**MISSISSIPPI DEPARTMENT OF TRANSPORTATION
TABLE OF CONTENTS**

PROJECT: STP-0022-04(063)/102607303 - Pontotoc

SECTION 904 - NOTICE TO BIDDERS NO. 594

SUBJECT: Plan Correction

WORKING NUMBER
PSP-11
SHEET NUMBER
1011

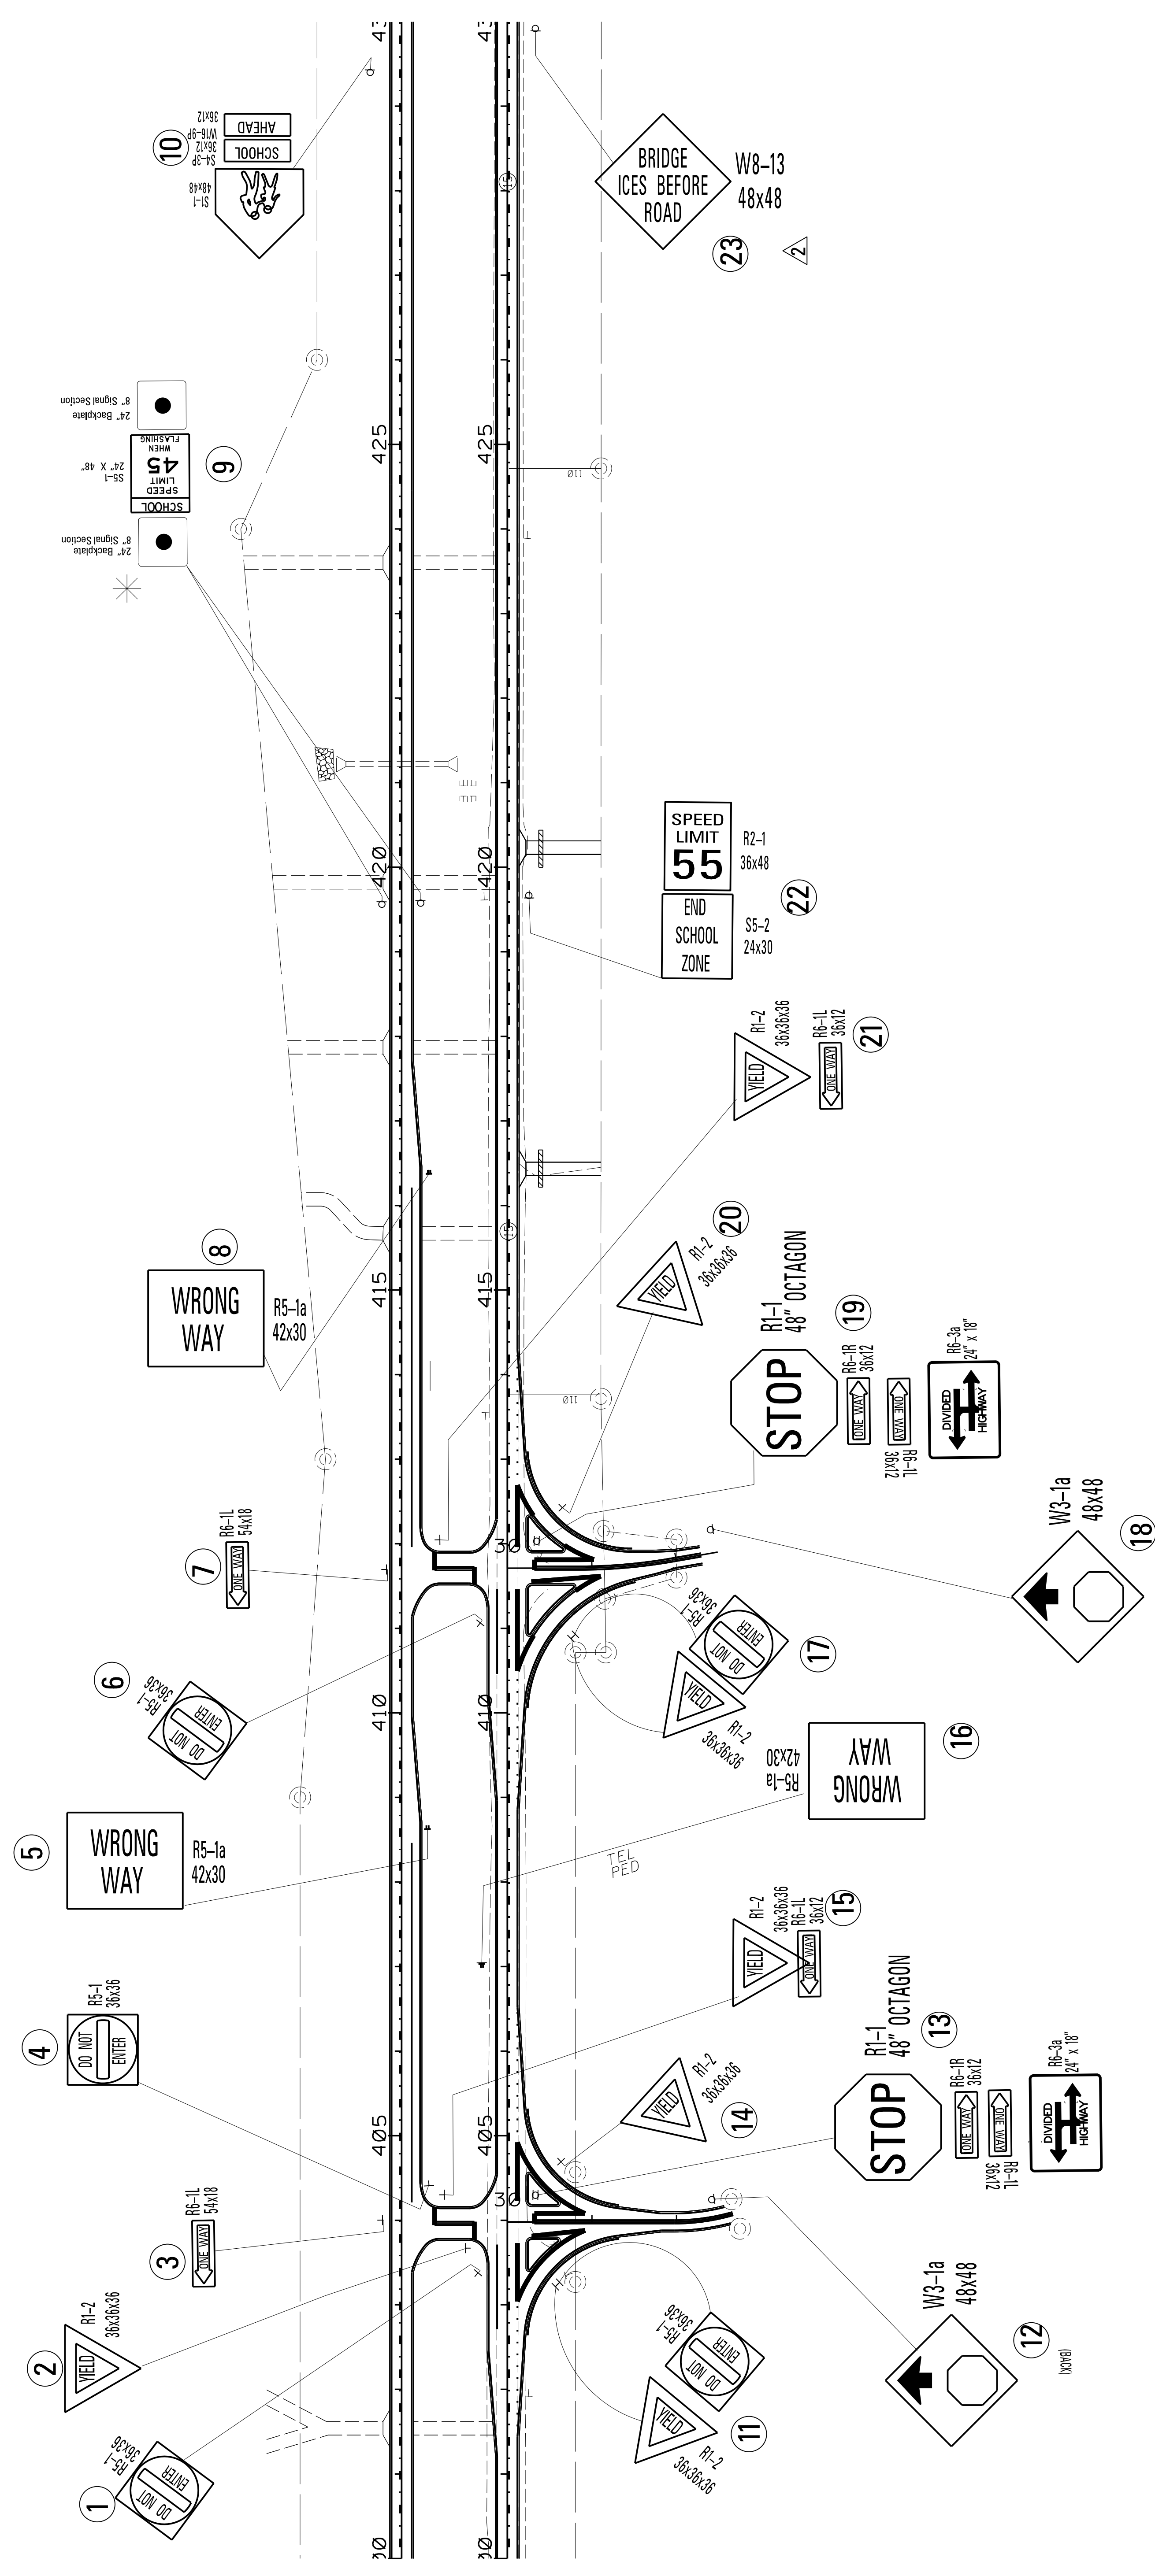
W3-1a shall be 500' from stop bar.

R5-1a shall be 450' from nose point.

FILENAME: TSI.DGN	CHECKED	DATE
DESIGN TEAM		
SHEET NUMBER		2001

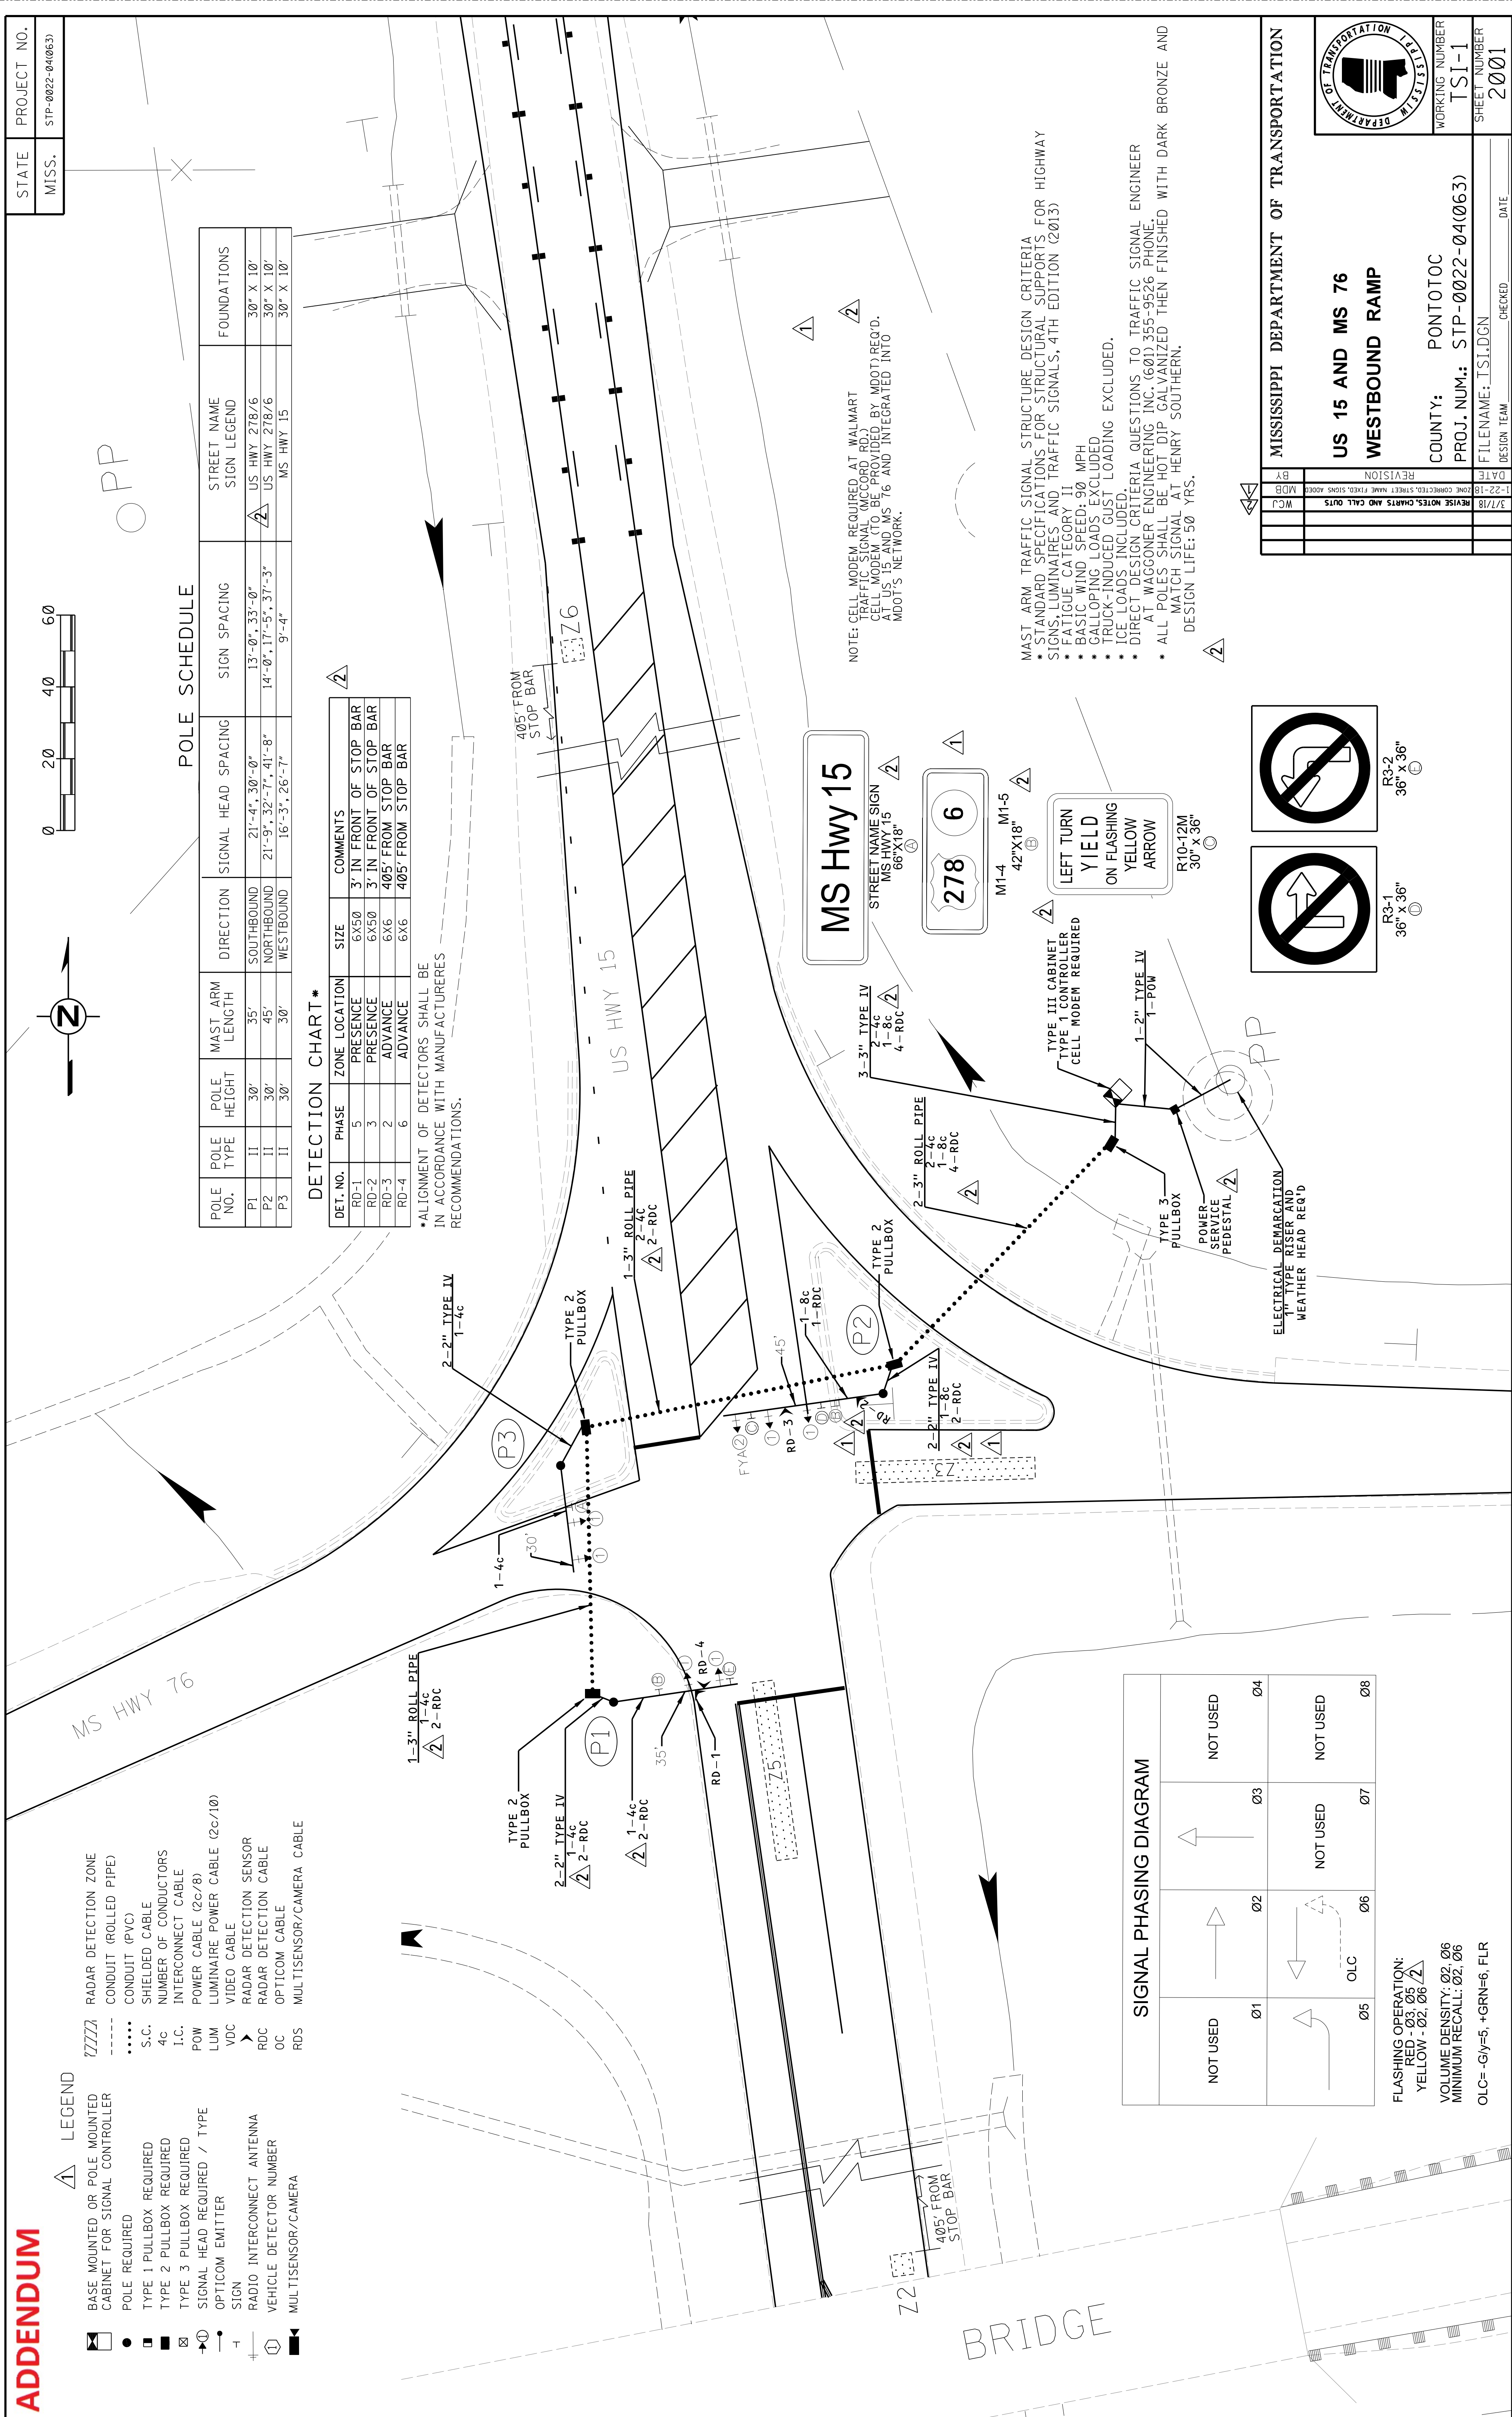
3/7/18	REVISE NOTES, CHARTS AND CALL OUTS	WCU
1-22-18	ZONE CORRECTED, STREET NAME FIXED, SIGNS ADDED	MDB
3/7/18	REVISION	DB

NOTE: CELL MODEM REQUIRED AT WALMART TRAFFIC SIGNAL (MCCORD RD.)
CELL MODEM (TO BE PROVIDED BY MDOT) REQ'D.
AT US 15 AND MS 76 AND INTEGRATED INTO
MDOT'S NETWORK.
